Integration of Spectrometer PFM BDAs:
alignment issues

Ref: SPIRE-RAL-NOT-
002194

By: Marc Ferlet (RAL)

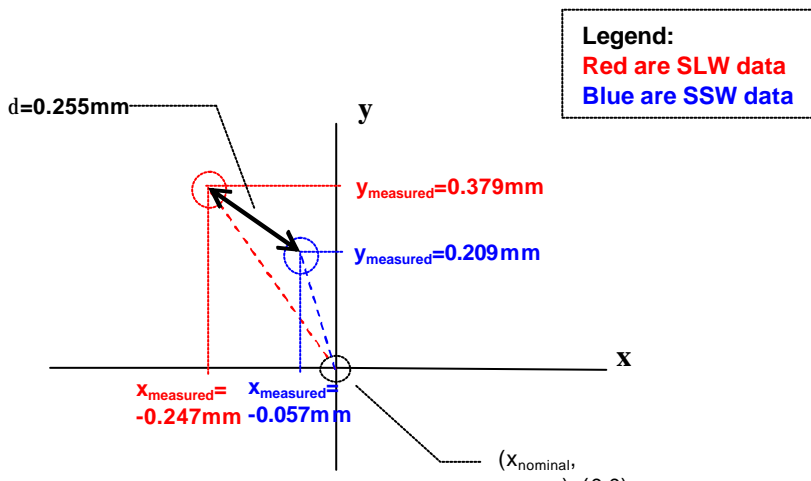
The deviation found (total i.e. ambient and cold measurement from RD2) from the nominal plane along the local z axis is +0.195mm. This will translate into a defocus of the SSW BDA in operation wrt the nominal best focal plane. This is well within the $\pm 0.5 \text{mm}$ allowed margin. This is also acceptable as it's still a small value when compared to the F/5 depth-of-focus at SSW wavelengths.

The lateral in-plane shift of the BDA centre wrt to nominal centre is found to be (total i.e. ambient and cold measurement):

- along X: $-0.057 \pm 0.05 \text{mm}$
- along Y: $+0.209 \pm 0.05 \text{mm}$

so that the max displacement from centre is $\sqrt{dx^2+dy^2} \sim 0.217 \pm 0.100 \text{mm}$. This represents $\sim 9.6\%$ of the SSW pixel size and, at the entrance focal plane (CFIL1 location), is equivalent to 0.377mm displacement which is within the oversize (wrt FoV) of the shaped aperture at CFIL1. Nevertheless this means that the centre of the SSW FoV is shifted on-sky by $\sim 2.7 \pm 0.5 \text{arcsec}$ wrt the nominal location in the Herschel coordinates system but this does not affect directly the performances of the SLW channel.

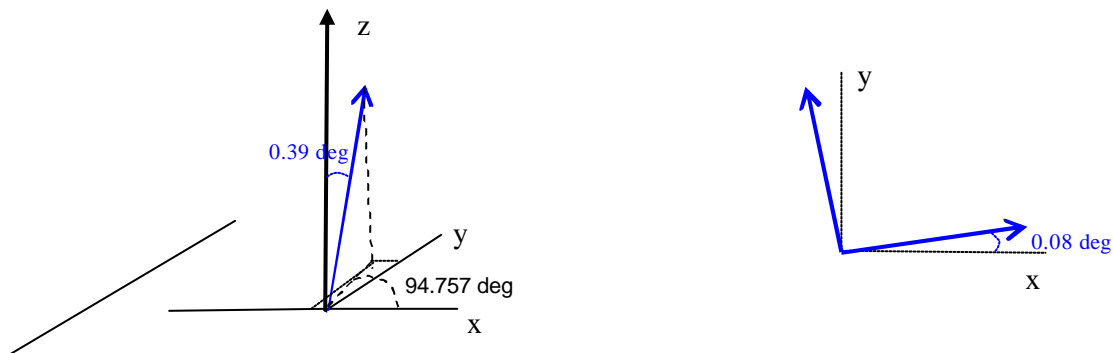
The measured tilt of the as-built x-y plane compared to the nominal one is found at ambient to be 0.39deg wrt the local z axis. Although this measurement is at ambient only, this is within the acceptable limit of ± 30 arcmin= ± 0.5 deg tolerances around the gut ray which nominally is aligned with the local z axis at the centre of the array.

NB: in RD2, comments are made about a tilt about x of 0.34deg during cryo-cycling. The orientation is unknown and as well as if there is an associated rotation about y. If this tilt about x is positive, it will compensate almost completely the initial ambient one. If the tilt is negative, it will add to the ambient one (mostly in the yz plane as seen below) and will lead to a tilt beyond the initial specifications. It is not known if this tilt is reproducible over multiple cryo-cycles.

From considerations above, it is suggested not to correct for SLW tilt and rotation as values are within specifications. **For SSW, due to uncertainty wrt potentially large tilt of the BDA wrt the interface, it is suggested to compensate at interface plate level the known ambient tilt in the yz plane by a**

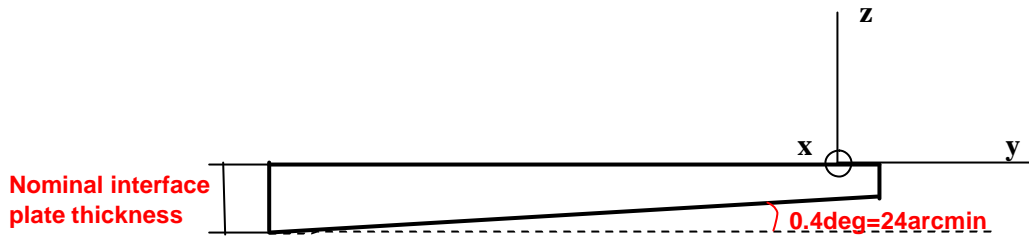
- SSW interface: The alignment data regarding the PFM SSW BDA indicates a location and orientation within the defined requirements to maintain the required performances. Only the uncertainties regarding tilt about x during cooldown can induce a general feedhorn plane angular misalignment beyond the required $\pm 0.5\text{deg}$. The proposed correction requires a slope on one side of the interface plate as shown below (local coord. system as per drawings above):

NB: the removal of material from the nominal constant thickness interface plate will produce an axial shift along +z which will also compensate partially the measured z shift reported above for SSW.
